I/AQ/U-01  
UPDATE  
to  
PROOF OF EVIDENCE  
on  
AIR QUALITY  
[I/AQ-01]  
Mr Jonathan Brooks  
On Behalf of It's Our City  
Planning Inquiry APP/A2335/V/09/2095002  
Canal Corridor North Site, Lancaster  
Contact: [jonb@itsourcity.org.uk](mailto:jonb@itsourcity.org.uk)

June 2009

Figure1 - The Model Verification Method

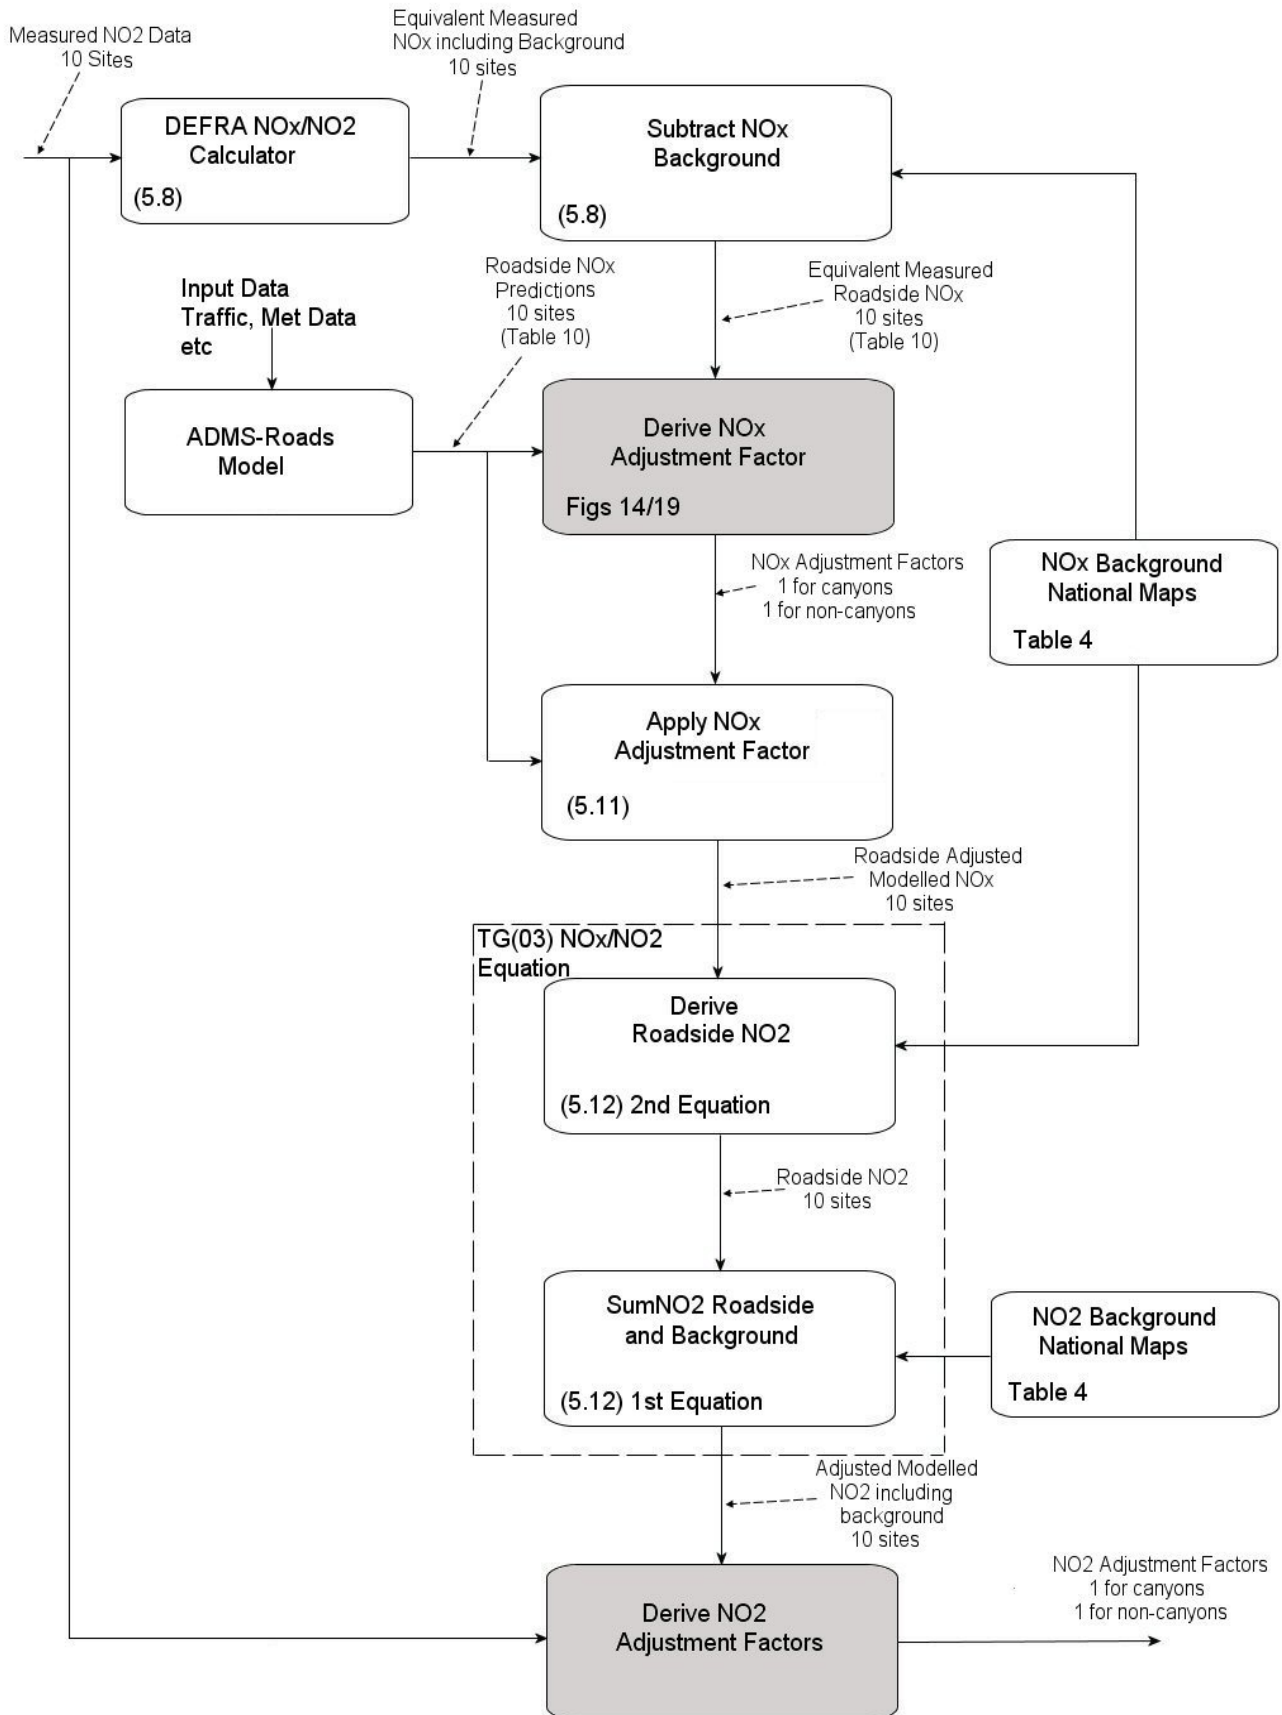
Since some details of the modelling process employed are not clear, I have created Figure 1 from the explanations in the text to aid in understanding which can be found on page 15.

The shaded boxes in Figure 1 on page 15 show the positions in the data pipeline where these undocumented uncertainties arise in the verification process.
